SR 44 @ SCOTT ROAD TRAFFIC SIGNAL INSTALLATION

RESPONSE TO QUESTIONS

BID NUMBER: 21-42001-002

DEPARTMENT OF TRANSPORTATION STATE OF GEORGIA	
CONSTRUCTION DETAIL	
STRAIN POLE AND MAST ARM FOUNDATIONS	
NOVEMBER 2020 NO SCALE	NUMBER TS-05

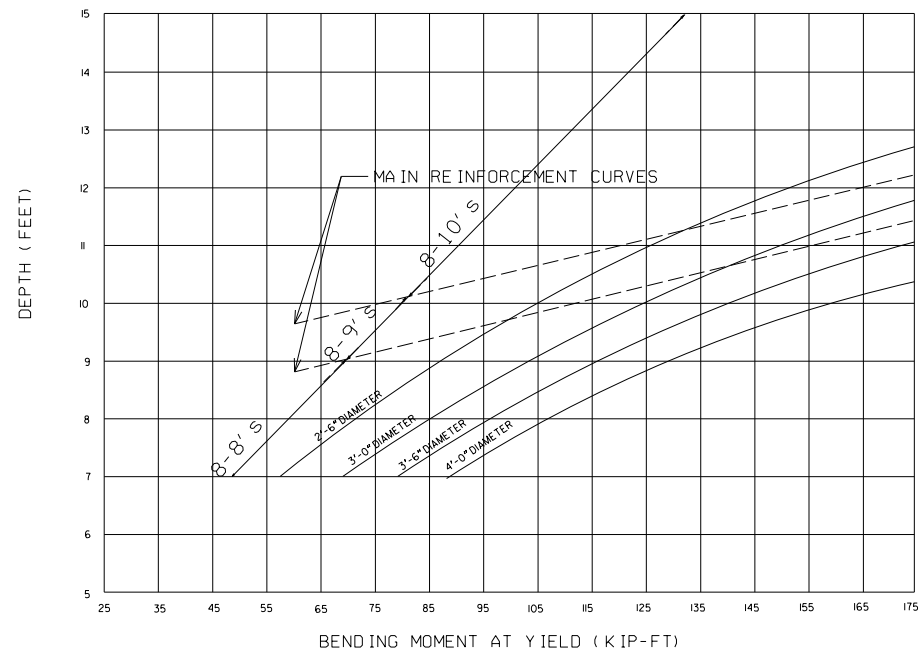
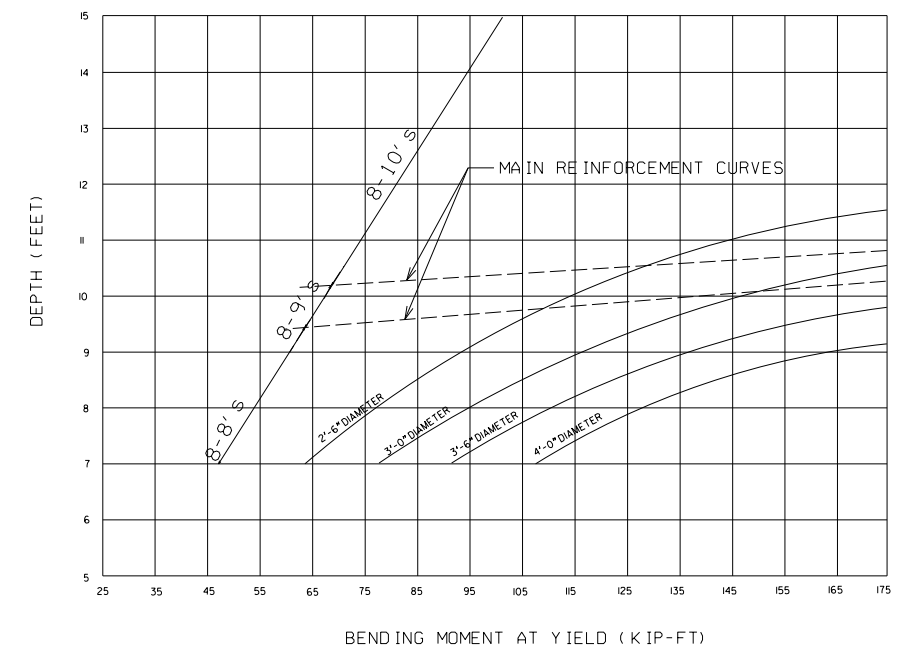
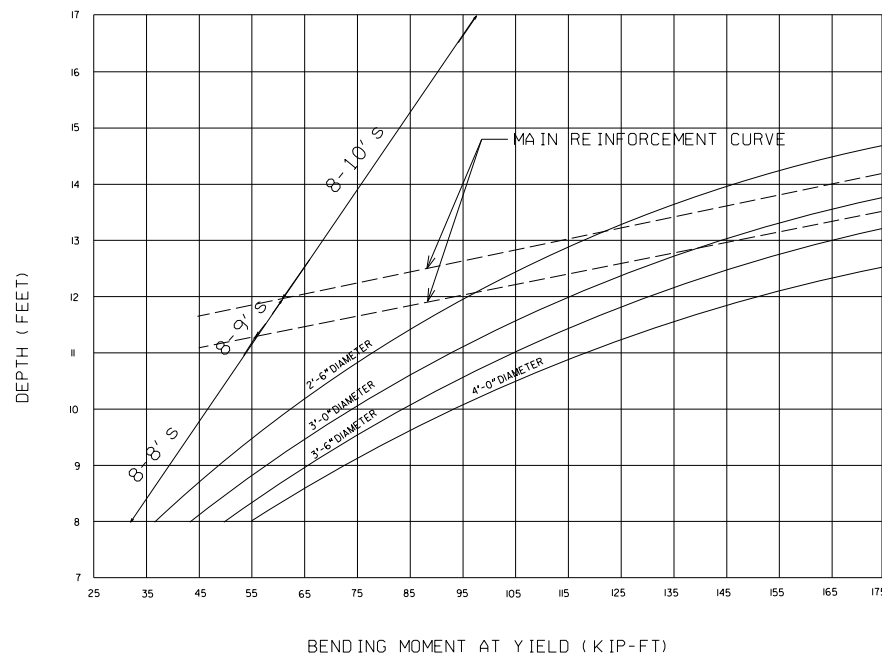
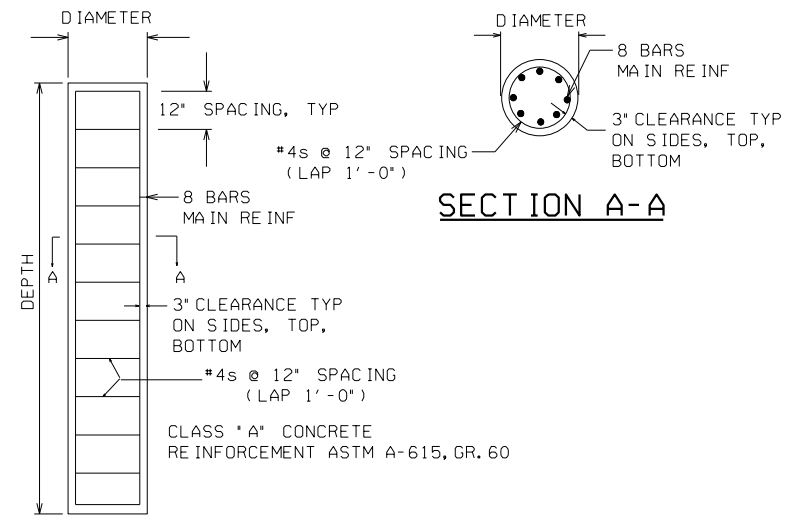
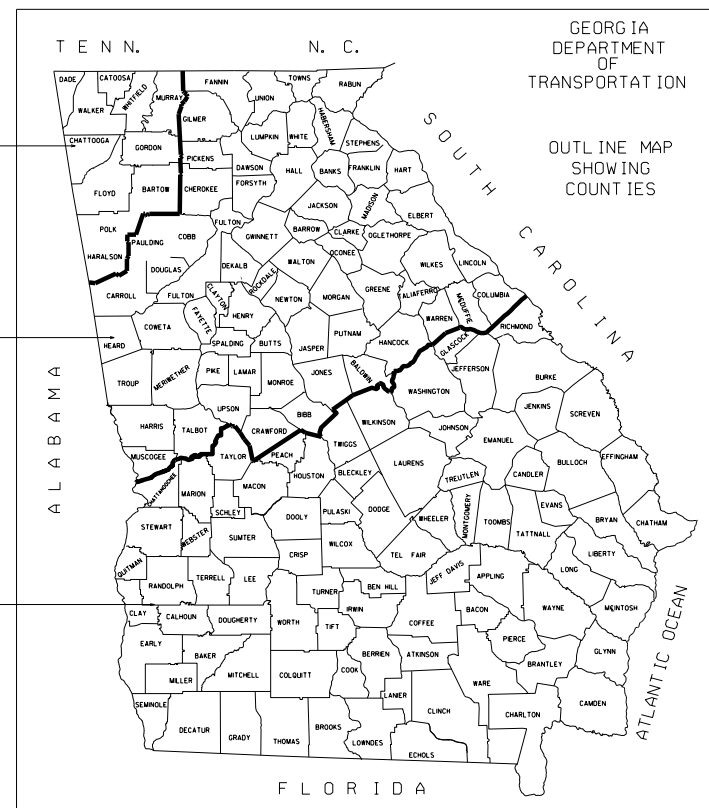
One of the issues we are having with a lot of project coming out to after April 15. The new GDOT spec went into effect. The new mast arm spec in particular has a major effect on pricing, pole, and foundation sizes. Mast arm prices have doubled and tripled.

I am assuming the Alternate bid is to include cost for the mast arms due to note 1 stating the city “may” purchase the mast arms. Can you specify which GDOT specification will be required should the contractor be responsible for supplying the poles?

Please note that the BASE BID is where the county is purchasing the strain poles/mast arms. Refer to Note 1.

Please refer to Addendum #4 and the Response to Questions dated 5/10/2021 for clarifications.

The county is aware that beginning on 4/16/2021, the following GDOT 2021 Specification for Strain Pole and Mast Arm Foundations (TS-05), which was adopted by GDOT on March 19th, 2021, shall be applicable to all projects on state right-of-way. This new specification will be applicable to this ITB.
